3/31/09	Added General Note (F)
DATE	REVISION	
STATE OF HAWAII DEPARTMENT OF TRANSPORTATION HIGHWAYS DIVISION BRIDGE GENERAL NOTES INTERSTATE ROUTE H-1 EXTENSION AND REPAIR OF SCHOOL STREET ON-RAMP RETAINING WALL Project No. H11-01-08 Scale: As Noted Date: Feb., 2009

3/31/09	Revised and/or Added Callouts and Legend
DATE	REVISION
STATE OF HAWAII DEPARTMENT OF TRANSPORTATION HIGHWAYS DIVISION RETAINING WALL REPAIR and EXTENSION EXISTING SITE PLAN INTERSTATE ROUTE H-1 EXTENSION and REPAIR of SCHOOL STREET ON-RAMP RETAINING WALL Project No. H11-01-08	
Scale: As Noted	Date: Feb, 2009
SHEET No. Q3 OF 34 SHEETS

RETAINING WALL REPAIR and EXTENSION

DETAIL 2
Scale: 1"=1'-0"
Q17, Q19, Q20, Q25A

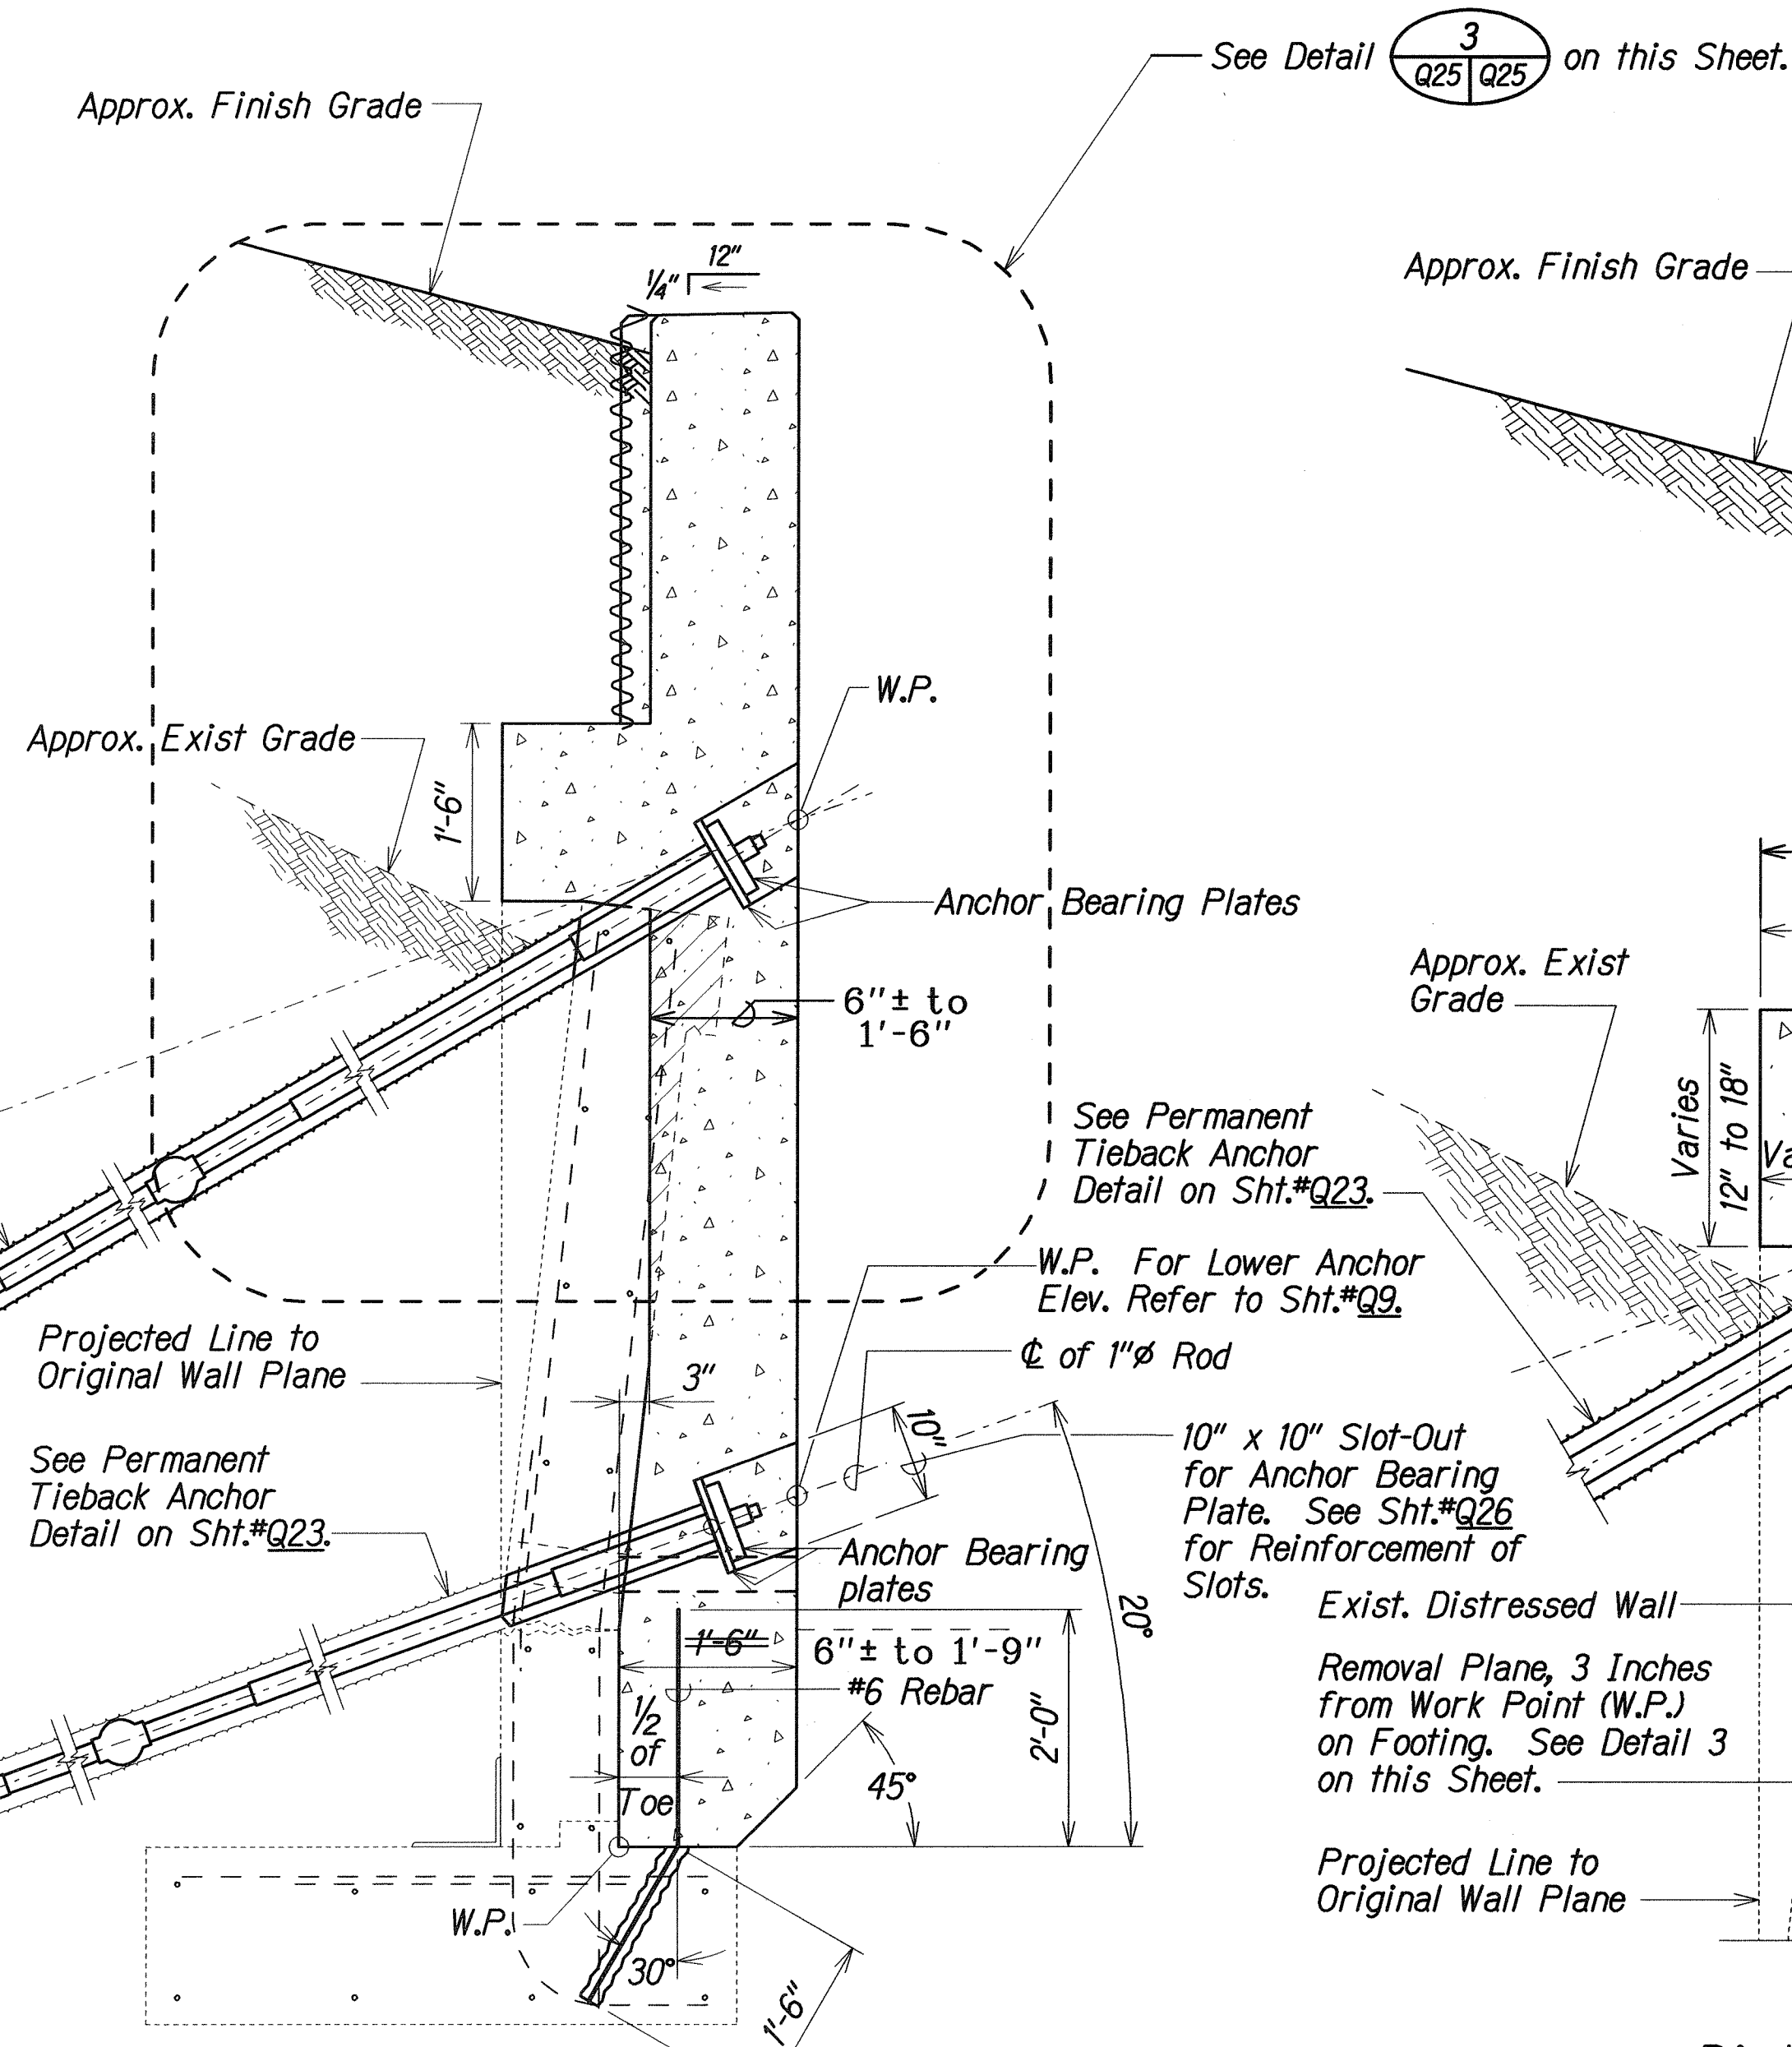
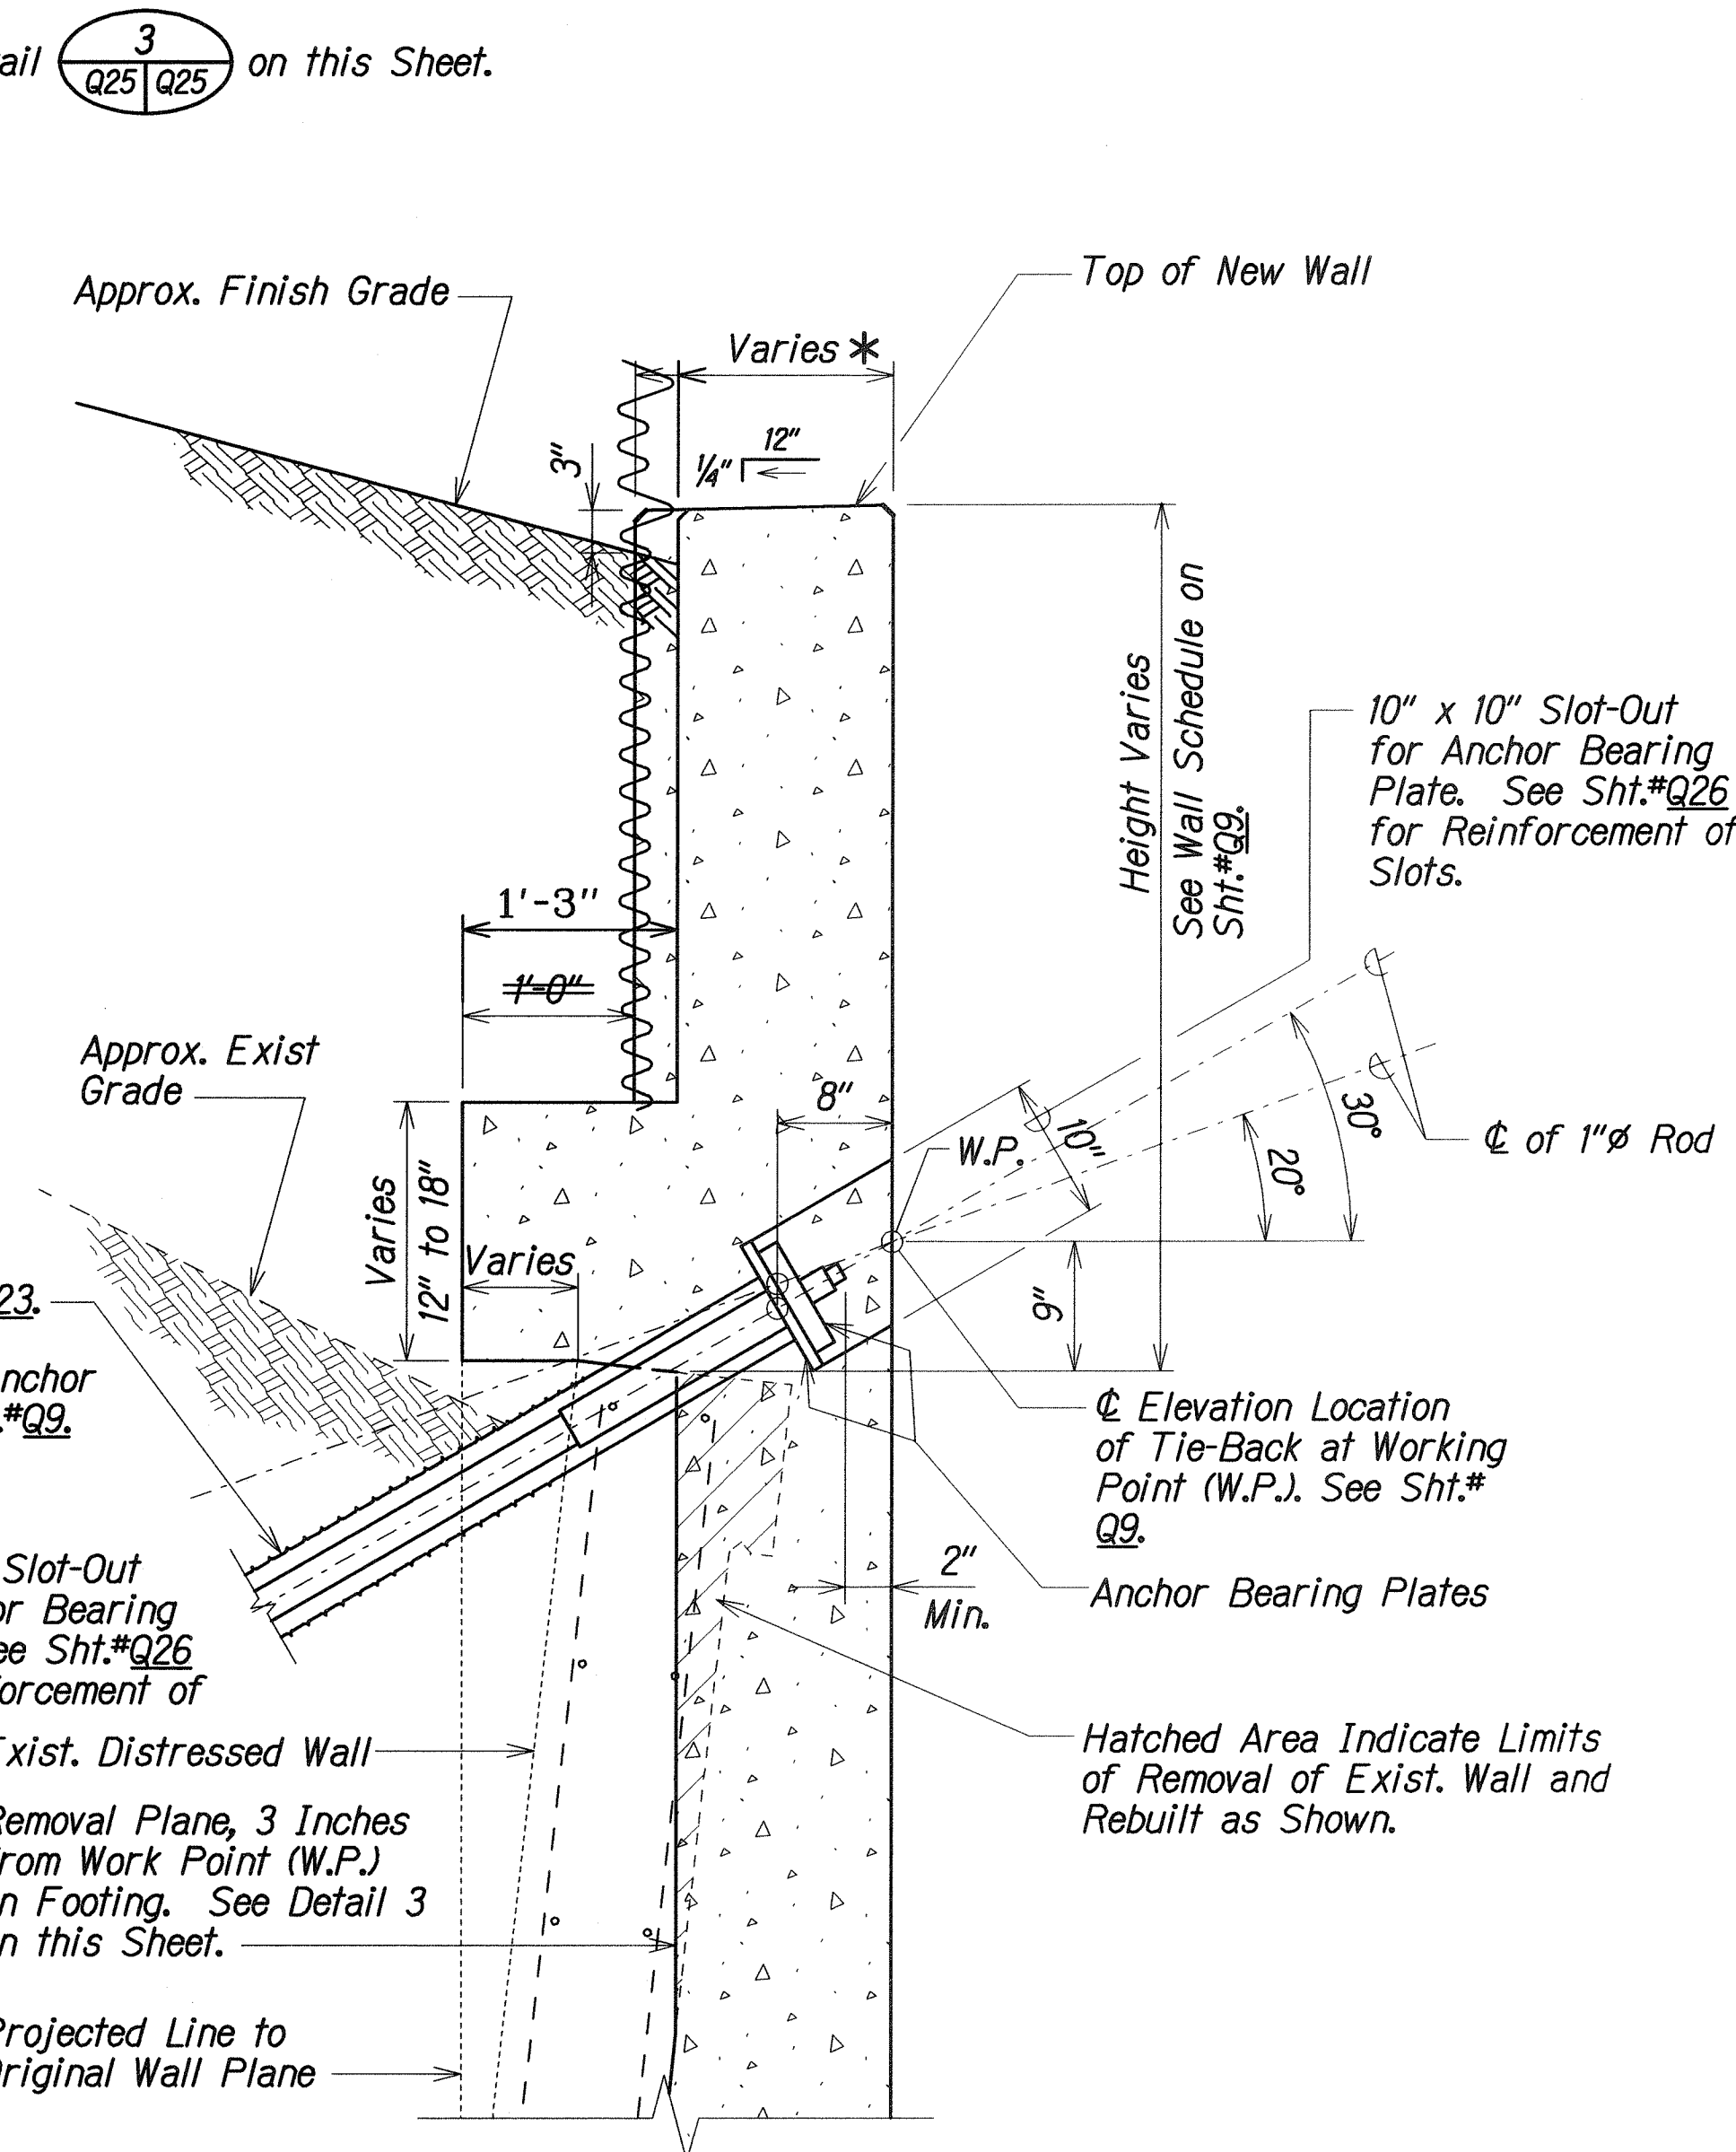
Added Note No. 2 for Walls K, L & M. Added Sheet Number to Section Symbol	8/17/09
DATE	REVISION
	STATE OF HAWAII DEPARTMENT OF TRANSPORTATION HIGHWAYS DIVISION
	RETAINING WALL REPAIR TIEBACK ANCHOR PLACEMENT DETAIL INTERSTATE ROUTE H-1 EXTENSION AND REPAIR OF SCHOOL STREET ON-RAMP RETAINING WALL Project No. H11-01-08
Scale: As Noted	Date: Feb, 2009
SHEET No. Q25 OF 34 SHEETS

- NOTES:
- After Anchors have been Proof Tested and Lockoff Loads Applied, Reinforce Slot and Seal with Concrete, similar in Strength and Texture to Added Wall Concrete. Appearance shall be acceptable to the Engineer with no tell tales of Slot-Outs.
 - For Distressed Walls K, L & M, Refer Sht.#Q25A.
 - * See Det. 2 for dimensions.
